Planning Commission Agenda Report

February 28, 2018
Item 6.c.

- SUBJECT:** P17-0907
- APPLICANT:** Robert Lyman, Johnson Lyman Architects
- PROPERTY OWNER:** Dennis Winslow
- PURPOSE:** Workshop to review and receive comments on a Design Review application to retain an existing, approximately 1,042-square-foot, single-story single-family residence and to construct an approximately 3,841-square-foot, two-story, two-unit apartment building behind the existing residence and related site improvements.
- LOCATION:** 4722 Harrison Street
- GENERAL PLAN:** High Density Residential
- SPECIFIC PLAN:** Downtown Specific Plan – High Density Residential
- ZONING:** RM-1,500 (Multi-Family Residential), Core Area Overlay District
- EXHIBITS:**
- A. [Discussion Topics](#)
 - B. [Project Plans dated "Received January 17, 2018"](#)
 - C. [Arborist Report dated October 18, 2017](#)
 - D. [Location and Notification Map](#)

Figure 3: Site Plan

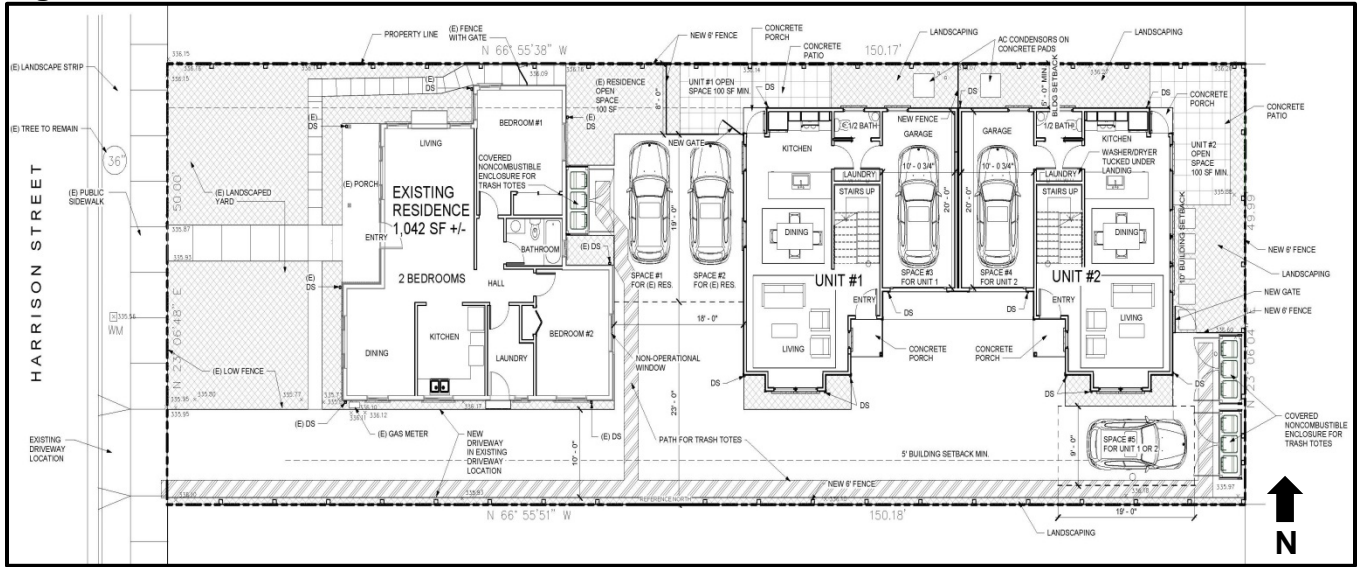
As previously described, the existing driveway off Harrison Street would be removed and replaced with a new driveway in the same location. This new driveway would also provide pedestrian access to the new units at the rear of the site. In an RM district, a separate pedestrian walk is normally required between the units and the front property line. However, on smaller in-fill sites, such as the project site, staff has in the past been supportive of providing relief from this requirement by allowing projects to utilize the vehicular driveway to serve both vehicular and pedestrian traffic. This concept has been recently supported and applied on two similar projects; one at 4745 Augustine St. and the other at 434 Rose Ave. Staff believes this approach should also be applied for the proposed project given the limited width of the project site, desire to maintain the existing single-family home on-site, and because of the relatively limited amount of vehicular traffic and low vehicle speeds along the driveway, which would limit vehicular and pedestrian conflicts.

In correspondence with the applicant, staff recommended the use of pavers and/or special paving within the new driveway and motor court area up to the front doors of the new apartment units. Staff also recommended the use of pavers and/or special paving be used within the uncovered parking spaces at a minimum within parking space No. 5 which would be visible from the street. Additionally, staff recommended a mow strip be included down the center of the driveway up to the front edge of the existing residence. As proposed, none of these recommendations have been incorporated into the project. Staff believes the incorporation of one or more of these recommendations would substantially increase the quality of the project aesthetics and better reflect the character of downtown's residential neighborhoods.

Staff notes that typically a minimum of 25 feet of backup distance is required for on-site parking on these types of in-fill projects and 23 feet of backup distance is currently proposed. Staff and the Planning Commission have supported reduced backup distances for in-fill projects on small, downtown in-fill sites in the past. An example of a project with reduced backup distance includes the project currently under construction at 273 Spring St. (multi-family apartments), where the Planning Commission supported a 20-foot backup distance. In this case, the applicant has provided a plan sheet (Sheet A6 in Exhibit B) with turning templates that demonstrate the provided backup distances are adequate for ingress/egress from each of the provided parking spaces. While staff acknowledges the path of travel is not ideal, because several movements may be needed to maneuver into the space, especially for a larger vehicle, staff believes 23 feet of backup distance can be supported given the small number of units and vehicles parked on site.

Figure 5: Proposed elevations

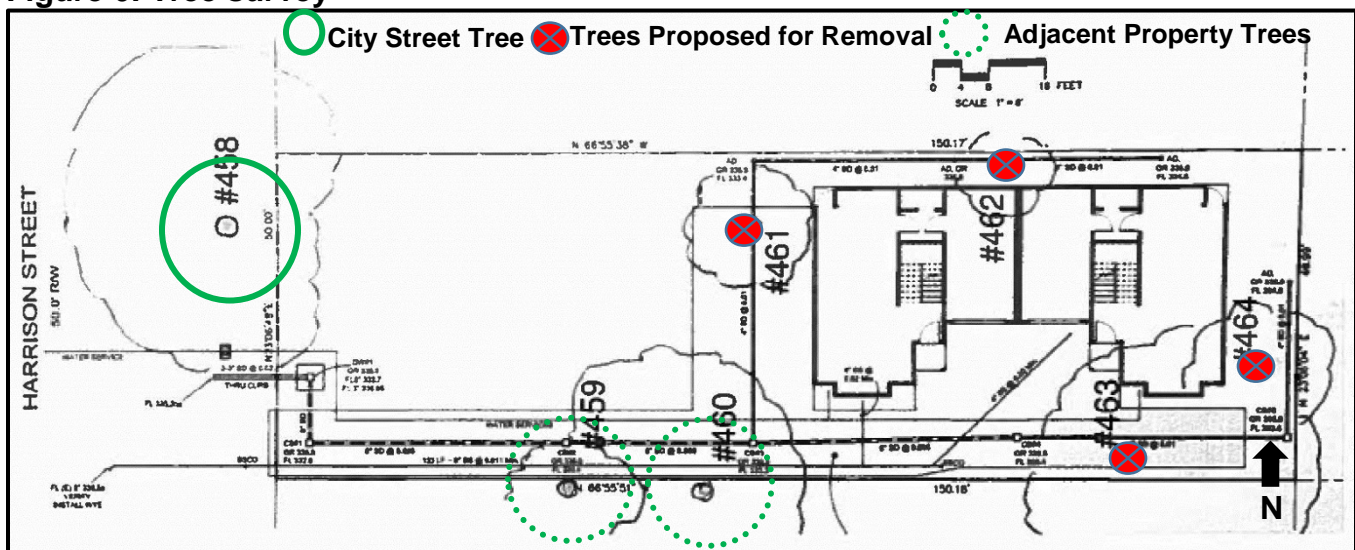
In staff’s view, the applicant has provided sufficient articulation on all building elevations to break up the two-story façades and provide visual relief. The proposed building height is also compatible with those of the surrounding neighborhood, which include a mix of one-story and two-story single- and multi-family homes. Staff also believes that the materials and colors are appropriate for the architectural style of the buildings.

Overall, staff generally believes that the design of the proposed apartment building is attractive and appropriate for downtown, conforms to the traditional character of the downtown, complies with the Downtown Design Guidelines, and would complement the existing buildings on Harrison Street and other areas in downtown. However, staff believes the building design could be further improved and refined through the incorporation of the following:

- Enhanced and high quality eave detailing such as exposed rafter tails, corbels, kickers, et cetera.
- More substantial (wider and deeper) window trim to provide articulation to the building façade.
- High quality windows with thick trim elements/profiles
- Carriage-style garage doors, recessed from the wall.
- Incorporating a more substantial and defined porch entry and raising the finished floor of the building to create a “step-up” to the front porch/entry from the ground plane.
